Re: C & D Farms No. 2, Permit No. M-1999-043, Technical Revision No. 4 (TR-04) Adequacy Review-01

Enclosure(s): Mining Plan Map approved with original application on May 15, 1999

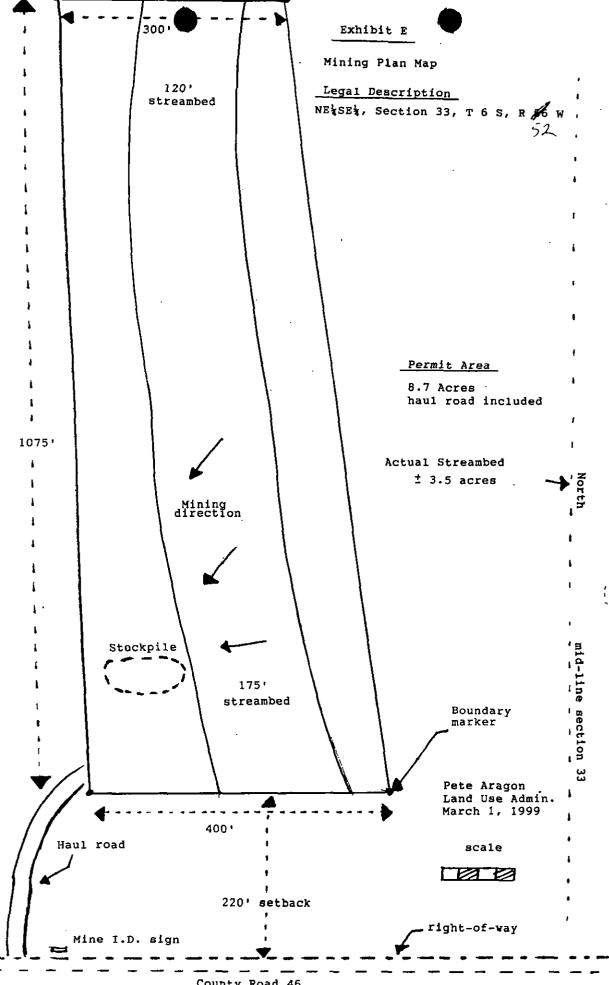
1) The original Mining Plan Map submitted with the 110c application that was approved on May 15, 1999 shows a 220 ft mining setback from the Co Rd 46 ROW (see enclosed map). <u>If this is a required setback</u>, please add it to the revised Mining Plan Map.
